UNITED STATES PATENT AND TRADEMARK OFFICE

Office Action Summary

09/848,819

DETAILED ACTION

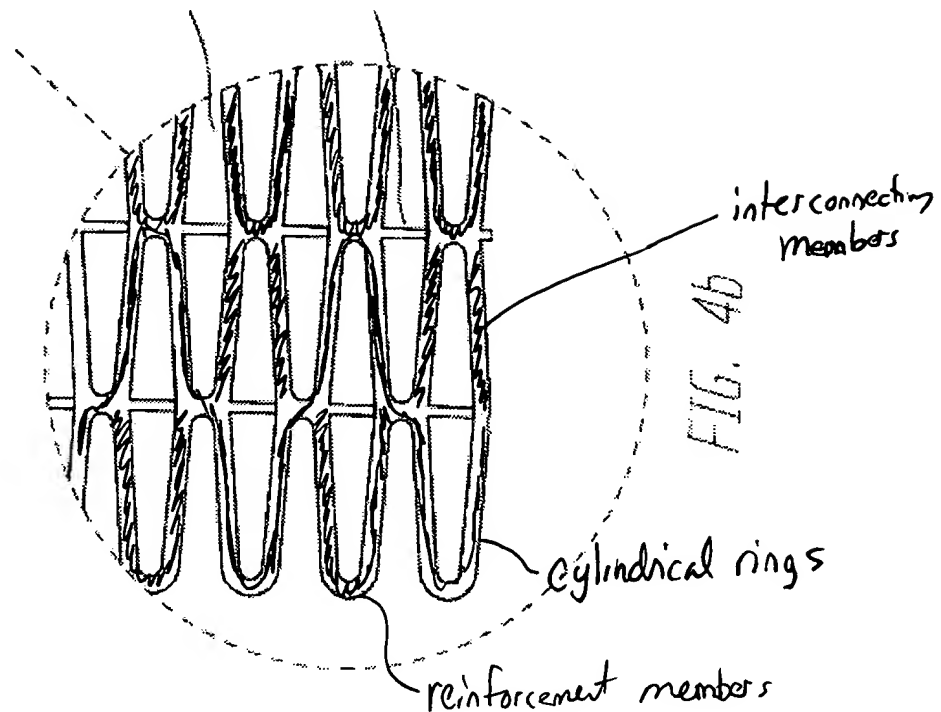
2. Claims 24,25 are rejected under 35 U.S.C. 102(e) as being anticipated by Klein US PN 5,593,442.

See figure 4B below specifically showing location of the cylindrical rings, reinforcing members, and interconnecting members. Also see abstract and lines 61-64 of col. 4 incorporating US PN 5,102,417, which discloses in lines 3-34 of col. 11 coatings for stents.

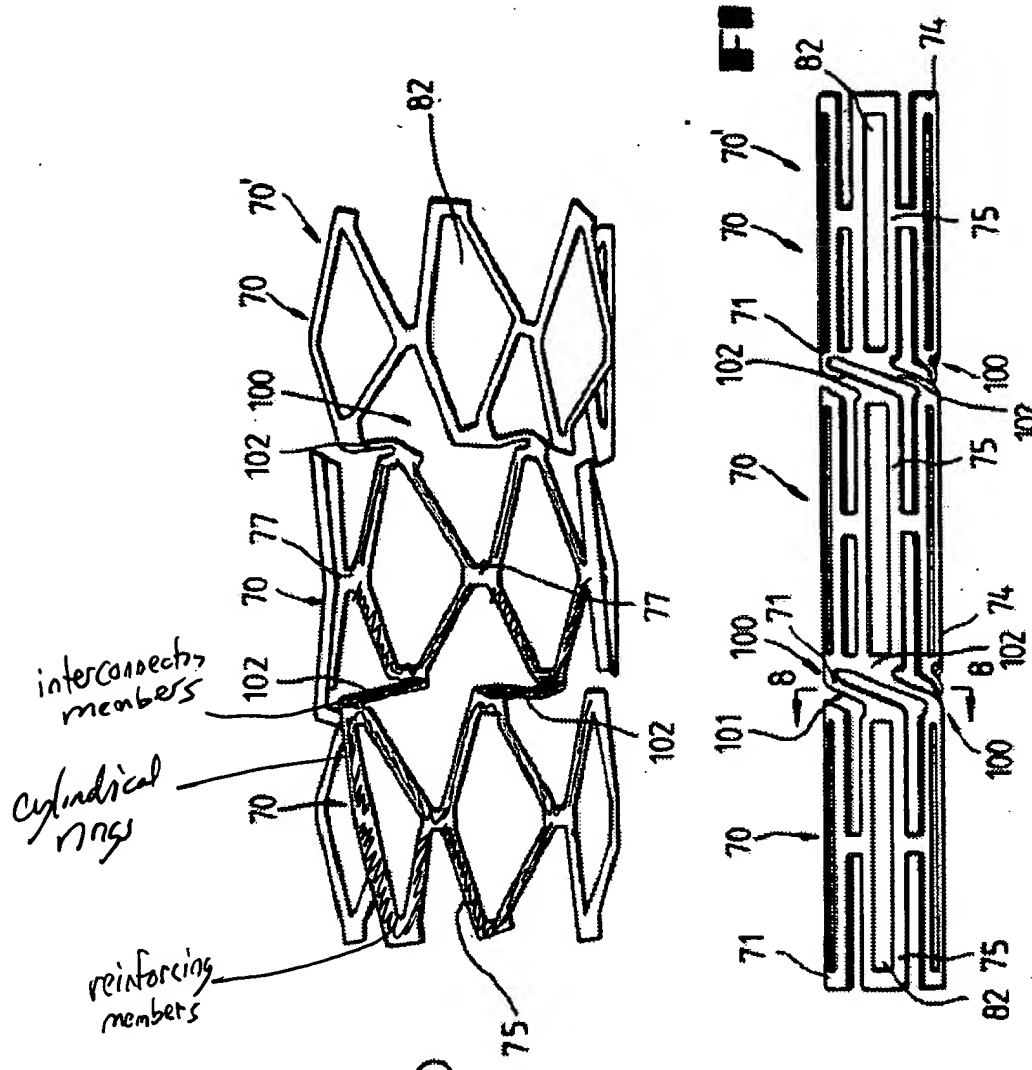
4. Claims 24-25 are rejected under 35 U.S.C. 102(b) as being anticipated by Palmaz US PN 5,102,417.

See figures 7 and 10 below specifically showing locations of the cylindrical rings, interconnecting members, and reinforcing members. Lines 3-34 of col. 11 disclose biocompatible coatings for use with stents.
